CONWAY
HISTORIC DISTRICT COMMISSION
MARCH

CONWAY HISTORIC DISTRICT COMMISSION MEETING

ROBINSON HISTORIC DISTRICT CERTIFICATE OF APPROPRIATENESS REVIEW CALVARY CHURCH SIGNAGE 1832 ROBINSON AVENUE

OLD CONWAY DESIGN OVERLAY DISTRICT CERTIFICATE OF APPROPRIATENESS REVIEW WEAVER NEW RESIDENCE 1914 SIMMS STREET

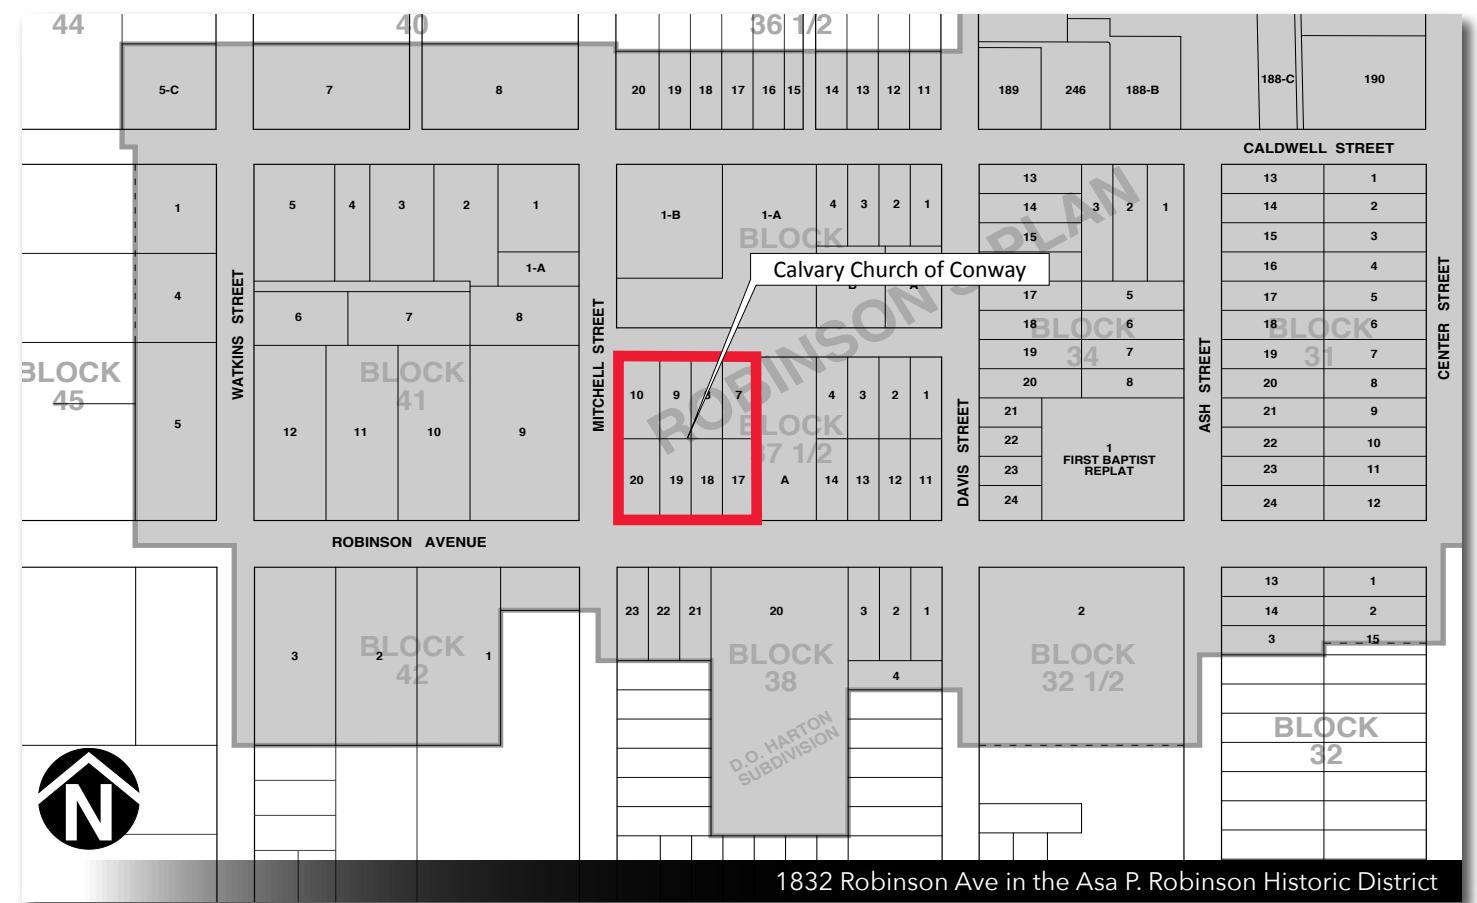
The free standing sign's style is traditional in nature and reasonably low to the ground. Sign construction materials appear to be wood or wood like. A list of construction materials has not been submitted. The applicant can describe the materials at the time of the meeting. The proposed size, height, and lighting seems appropriate.

The Historic District Commission should decide which style of sign and size allowances; either 4' x 4' at both locations or allow a 5' x 4' sign on Robinson and a 4' x 4' sign on Mitchell.

HDC Staff recommends approval of the basic size and design of the signs as submitted.

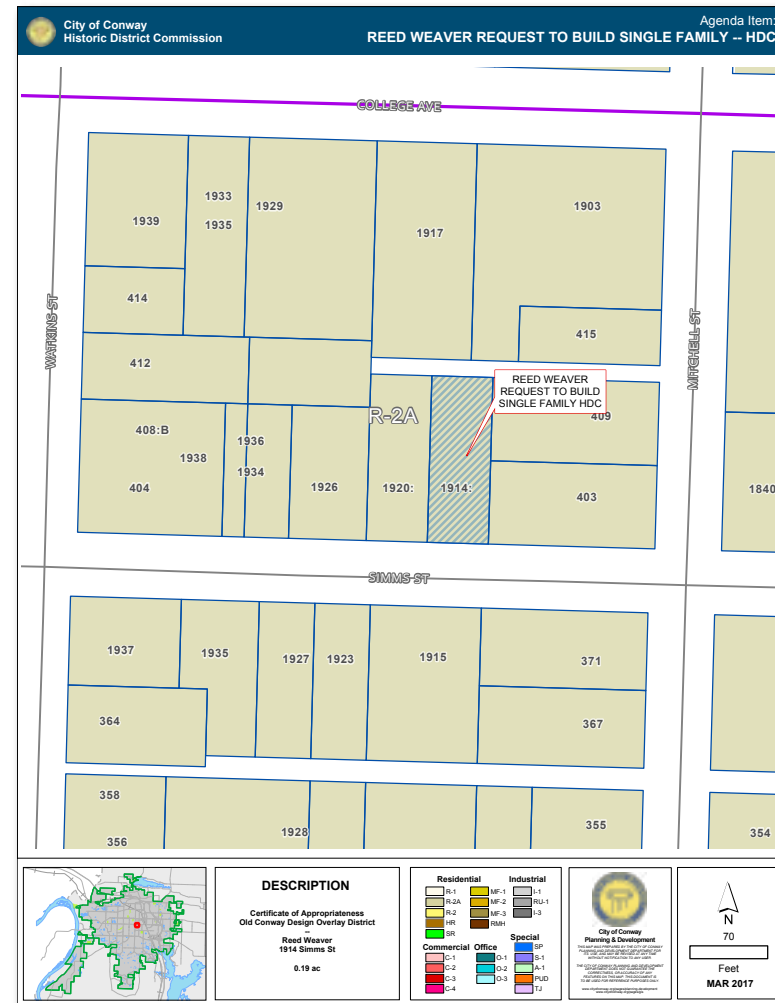
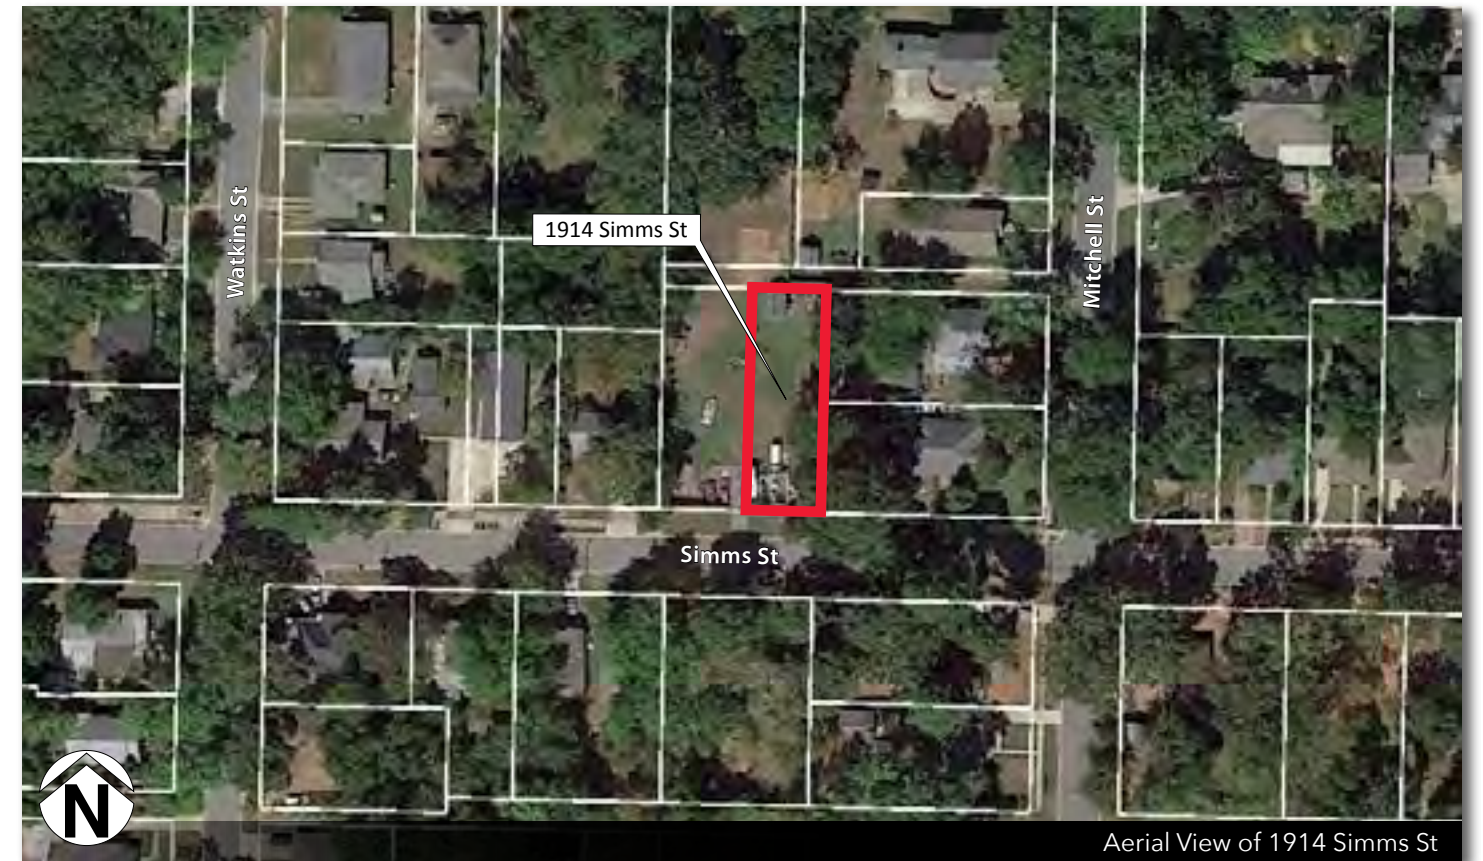
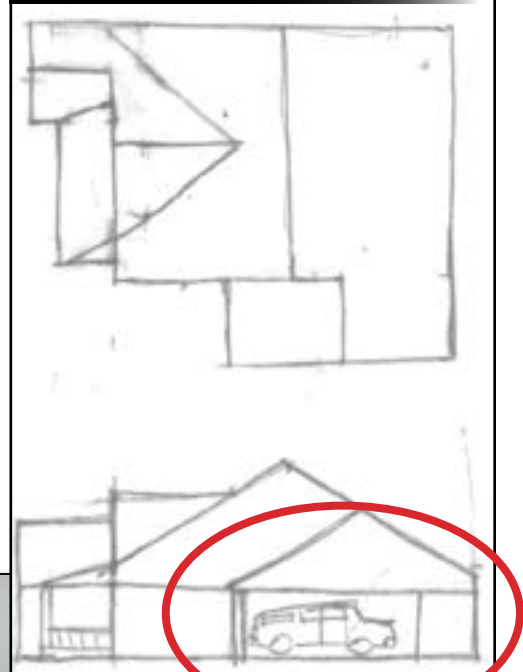
Driveway / Parking. There is an existing gravel driveway onto the vacant property. The proposed residence will be served by a driveway on the east side of the property. The driveway width is not specified. However, the residence has a 1 car carport. The driveway should be limited to 12 feet in width.

Height. The average height of area structure's eaves and cornices. Also, the first floor elevation / height relationship. The overall height and eave lines are appropriate. The first floor height should be minimally 9 feet floor to ceiling.

Complexity of form. The level of detailing and breaks in wall planes of a structure. The residence has appropriate detailing accomplished with wide window and door trim. The residence's wall planes are broken by a gabled front facade and a small porch. Gables are also used on the sides. The floor plan shows a carport with rear storage areas. The perspective view does not show the carport. A staff created sketch shows the roof line and carport side elevation.

Style. The style should compliment the existing and area structures. The residence is a modern interpretation of a minimal traditional bungalow/cottage with craftsman detailing. Entries, Porches, and Porticos. Appropriate entry points are provided. Porches are to be a minimum of 6 feet in depth. The front porch shown is small, but 6 feet in depth. Porch column width has a solid appearance. The column width should also be used on carport columns.

Doors and windows. The doors and windows shown have muntin dividers creating two over two windows. Simple one over one windows would be more appropriate than windows with false dividers.

Architectural Details, Siding, and Bricks. Eaves, brackets, dentils, cornices, molding, columns, trim, etc. The residence has detailing provided through wide door and window trim and open rafter tails over the front porch. These features add traditional detailing. The applicant has not provided the type of siding material. Fiber cement siding is preferred.

1. The residence shall be constructed as shown in submitted plans.
2. Driveway shall be concrete maximum of 12 feet in width.
3. The residence's front setback shall be approximately 26 feet from the property line.
4. Porch columns including carport columns shall be a trimmed out to approximately 8 inches by 8 inches.
5. Floor to ceiling height shall be 9 foot minimum.
6. Siding material?
7. Wide trim around windows and doors, open rafter tails, and mixture of siding shall be used as shown.
8. One over one windows may be used in line of false window dividers.
9. HVAC and utility equipment shall be appropriately located at the rear or side of the structure and/or appropriately screened.
10. A 4 foot sidewalk shall be constructed along Simms Street.

**OLD CONWAY DESIGN OVERLAY DISTRICT
CERTIFICATE OF APPROPRIATENESS REVIEW
WEAVER NEW RESIDENCE
1920 SIMMS STREET**

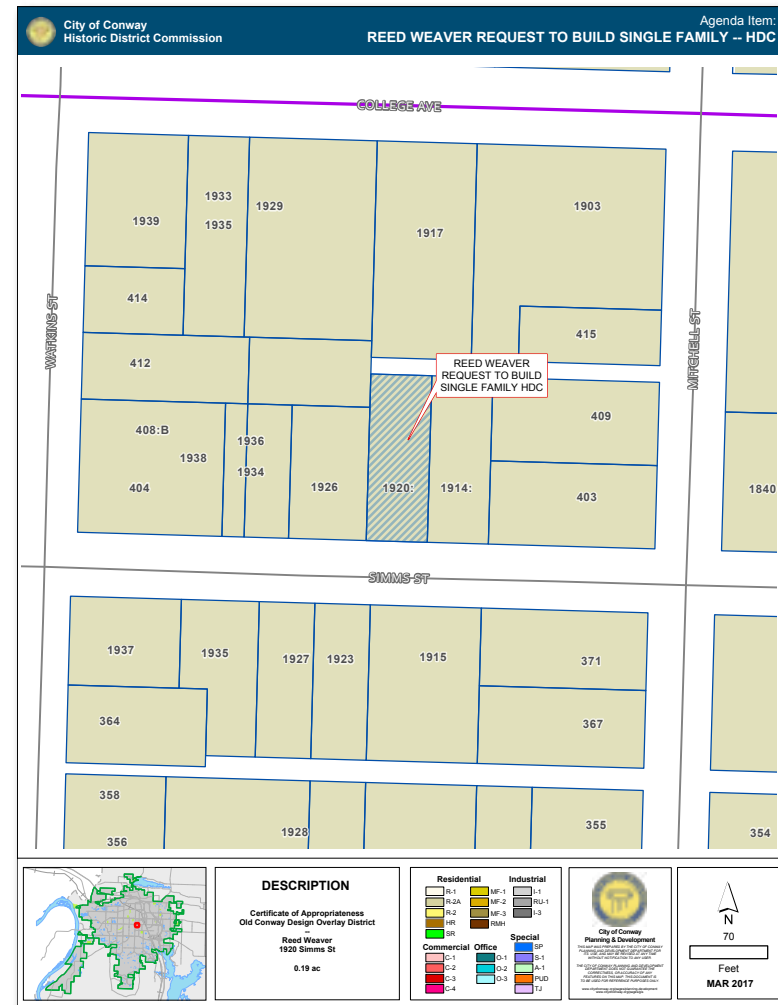
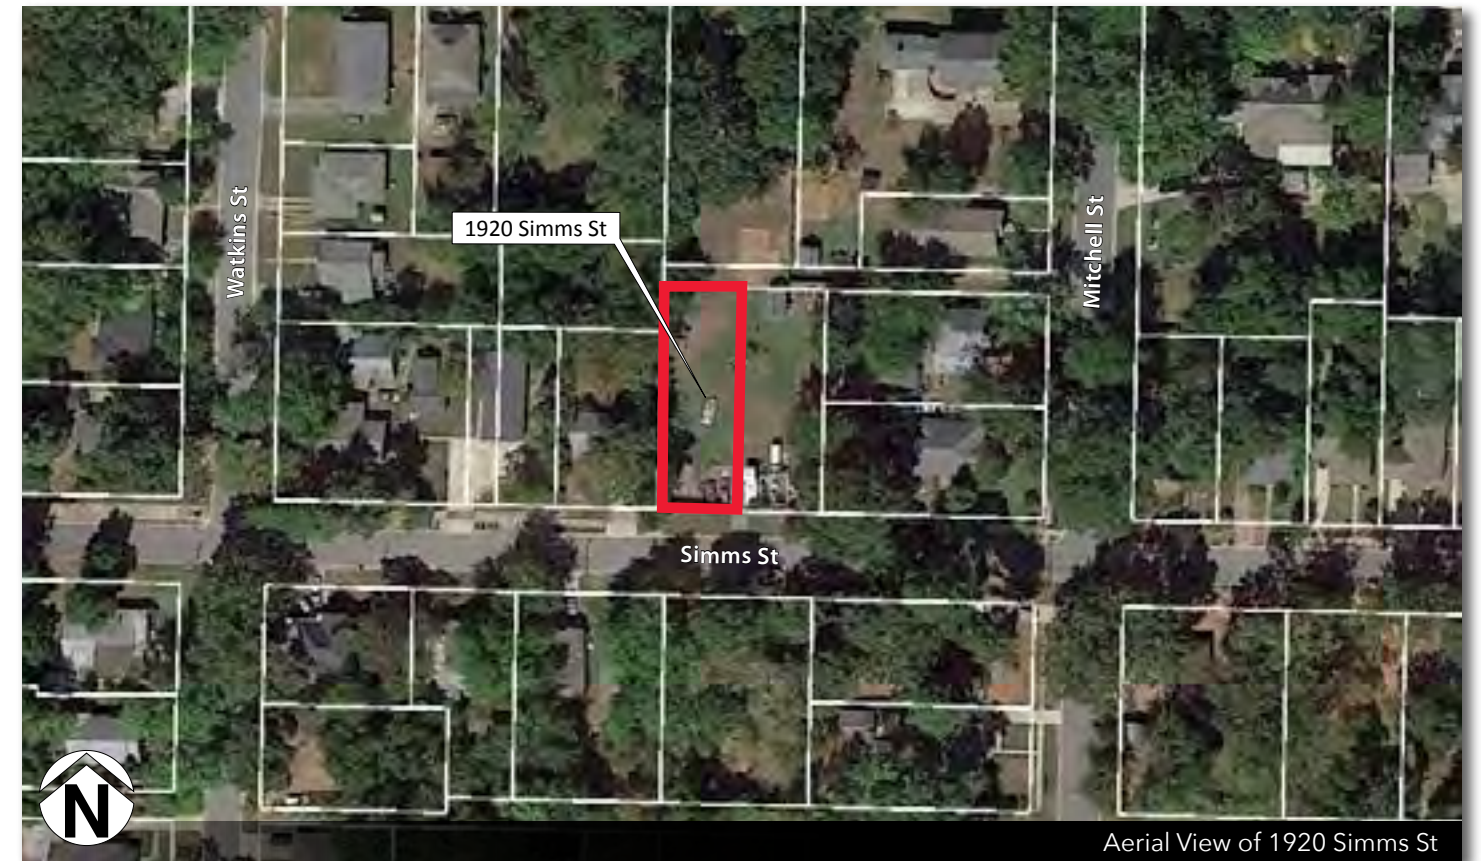
Driveway / Parking. There is an existing gravel driveway onto the vacant property. The proposed residence will be served by a driveway on the east side of the property. The driveway width is not specified. However, the residence has a 1 car carport. The driveway should be limited to 12 feet in width.

Height. The average height of area structure's eaves and cornices. Also, the first floor elevation / height relationship. The overall height and eave lines are appropriate. The first floor height should be minimally 9 feet floor to ceiling.

Complexity of form. The level of detailing and breaks in wall planes of a structure. The residence has appropriate detailing accomplished with wide window and door trim. The residence's wall planes are broken by a gabled front facade and a small porch. Gables are also used on the sides. The floor plan shows a carport with rear storage areas. The perspective view does not show the carport. A staff created sketch shows the roof line and carport side elevation.

Style. The style should compliment the existing and area structures. The residence is a modern interpretation of a minimal traditional bungalow/cottage with craftsman detailing. Entries, Porches, and Porticos. Appropriate entry points are provided. Porches are to be a minimum of 6 feet in depth. The front porch shown is small, but 6 feet in depth. Porch column width has a solid appearance. The column width should also be used on carport columns.

Doors and windows. The doors and windows shown have muntin dividers creating two over two windows. Simple one over one windows would be more appropriate than windows with false dividers.

Architectural Details, Siding, and Bricks. Eaves, brackets, dentils, cornices, molding, columns, trim, etc. The residence has detailing provided through wide door and window trim and open rafter tails over the front porch. These features add traditional detailing. The applicant has not provided the type of siding material. Fiber cement siding is preferred.

1. The residence shall be constructed as shown in submitted plans.
2. Driveway shall be concrete maximum of 12 feet in width.
3. The residence's front setback shall be approximately 26 feet from the property line.
4. Porch columns including carport columns shall be a trimmed out to approximately 8 inches by 8 inches.
5. Floor to ceiling height shall be 9 foot minimum.
6. Siding material?
7. Wide trim around windows and doors, open rafter tails, and mixture of siding shall be used as shown.
8. One over one windows may be used in line of false window dividers.
9. HVAC and utility equipment shall be appropriately located at the rear or side of the structure and/or appropriately screened.
10. A 4 foot sidewalk shall be constructed along Simms Street.

OLD CONWAY DESIGN OVERLAY DISTRICT CERTIFICATE OF APPROPRIATENESS REVIEW WEAVER RESIDENCE PORCH ADDITION 1826 SIMMS STREET

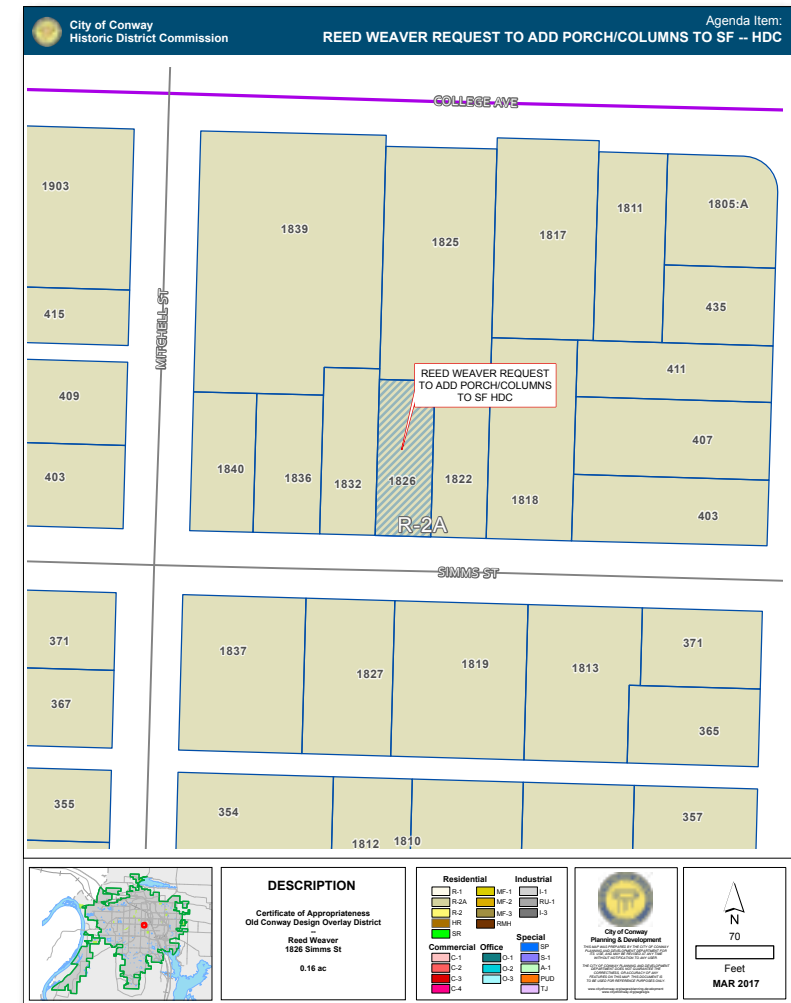
Complexity of form. The level of detailing and breaks in wall planes of a structure. The new porch addition adds a new level of complexity adding contrasting form and new shadow area.

Entries, Porches, and Porticos. Existing entry doors will remain unchanged. The porch will add a new more “human” scaled entry point and provide shelter form the elements. Guidelines state that a porch must be at least 6 feet in depth. The proposed porch is only 4 feet wide across the majority of its length. The allowed front setback limits the width of the porch. With the minimum allowed front setback of 19.8 feet, the porch could be widened to a 5 foot minimum depth.

Synthetic materials such as vinyl, aluminum, and synthetic stucco (EIFS products) are not historic cladding materials and should not be used. The existing residence is clad in vinyl siding. It is assumed that the new gable and trim will be clad with vinyl as well. The applicant can provide more details about siding materials at the meeting.

1. The porch addition shall be constructed as shown in submitted plans.
2. The addition may be clad with vinyl siding to match existing siding.
3. Roof shall be asphalt composition roof.
4. Porch depth shall be a minimum of 5 feet.

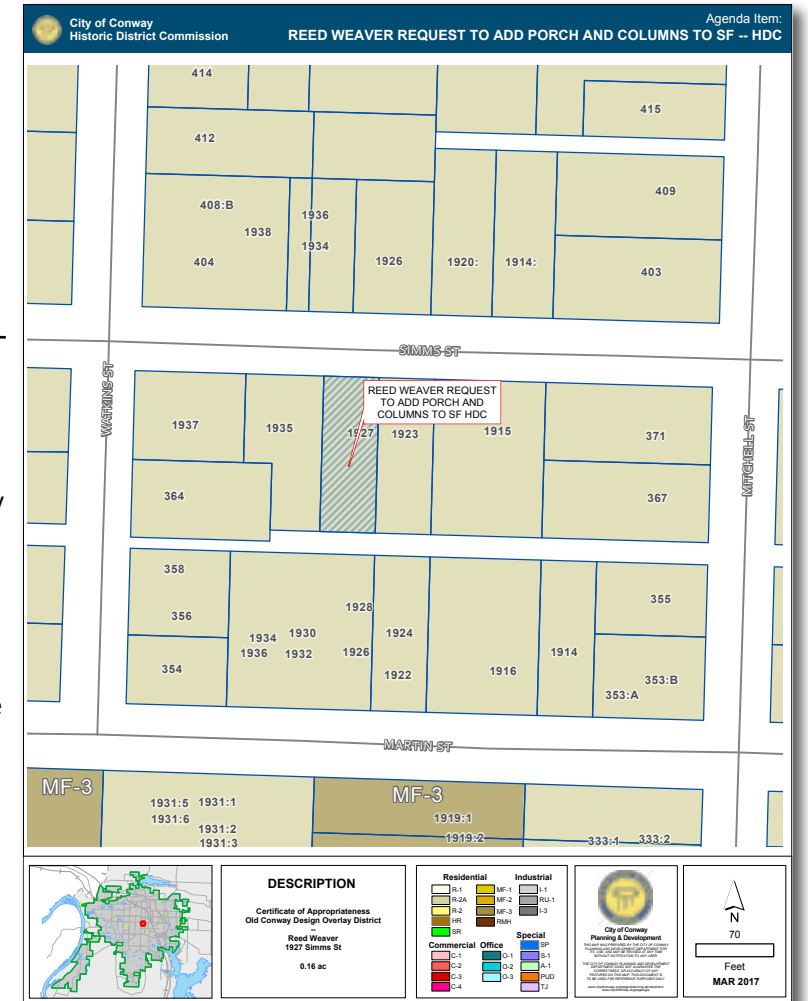
Complexity of form. The level of detailing and breaks in wall planes of a structure. The new porch addition adds a new level of complexity adding contrasting form and new shadow area.

Entries, Porches, and Porticos. Existing entry doors will remain unchanged. The porch will add a new more “human” scaled entry point and provide shelter form the elements. Guidelines state that a porch must be at least 6 feet in depth. The proposed porch is only 4 feet wide across the majority of its length. The allowed front setback limits the width of the porch. With the minimum allowed front setback of 19.8 feet, the porch could be widened to a 5 foot minimum depth.

Synthetic materials such as vinyl, aluminum, and synthetic stucco (EIFS products) are not historic cladding materials and should not be used. The existing residence is clad in vinyl siding. It is assumed that the new gable and trim will be clad with vinyl as well. The applicant can provide more details about siding materials at the meeting.

1. The porch addition shall be constructed as shown in submitted plans.
2. The addition may be clad with vinyl siding to match existing siding.
3. Roof shall be asphalt composition roof.
4. Porch depth shall be a minimum of 5 feet.
